From: Detlef Knappe [knappe@ncsu.edu]
Sent: 3/2/2017 1:04:18 PM
To: Sun, Mei [msun8@uncc.edu]; Strynar, Mark [/o=ExchangeLabs/ou=Exchange Administrative Group (FYDIBOHF23SPDLT)/cn=Recipients/cn=5a9910d5b38e471497bd875fd329a20a-Strynar, Mark]
CC: Lindstrom, Andrew [/o=ExchangeLabs/ou=Exchange Administrative Group (FYDIBOHF23SPDLT)/cn=Recipients/cn=04bf7cf26aa44ce29763fbc1c1b2338e-Lindstrom, Andrew]
Subject: Re: FW: Chemical Structures

Just finishing looking at Env. Sci. & Tech. Letters 2016 3 (12) 415 for use as a reference.

Legacy and Emerging Perfluoroalkyl Substances Are Important

Chemical	Structure shown in current IS	Should be changed to
PFMOPrA

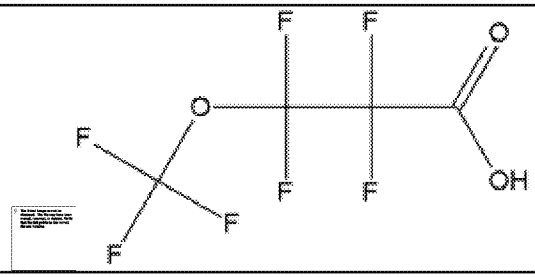
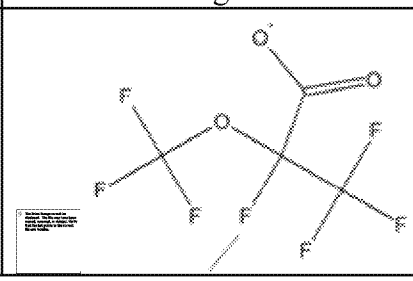
> Mark and Andy
>
> I drafted an email to the editor for updating the structures in SI. Please see if you think it's appropriate. For this draft I coped the structure in Mark's paper, but before I send it to the editor I will redraw them with the same software I used for other compounds to make the appearance more uniformed.
>
> Dear Dr. Arnold
>
> I am the corresponding author of the paper "Legacy and Emerging Perfluoroalkyl Substances Are Important Drinking Water Contaminants in the Cape Fear River Watershed of North Carolina" published in Env. Sci. & Tech. Letters 2016 3 (12) 415 (DOI: 10.1021/acs.estlett.6b00398). The authors were recently contacted about two of the molecular structures we are showing in the supporting information of the paper. The suggestion was made that the two chemicals are more likely branched instead of linear as follows:

I believe that the structural assignments for PFMOBA [$CF_3OCF_2CF_2CF_2COOH$] and PFMOPrA [$CF_3OCF_2CF_2COOH$] are most likely incorrect.

More reasonably the correct structures are isomers $CF_3CF_2OCF(CF_3)COOH$ and $CF_3OCF(CF_3)COOH$ respectively. I doubt that the MS/MS could tell the isomers apart.

After a review of our high resolution mass spectrometry results, we concur that the branched structures are more likely.
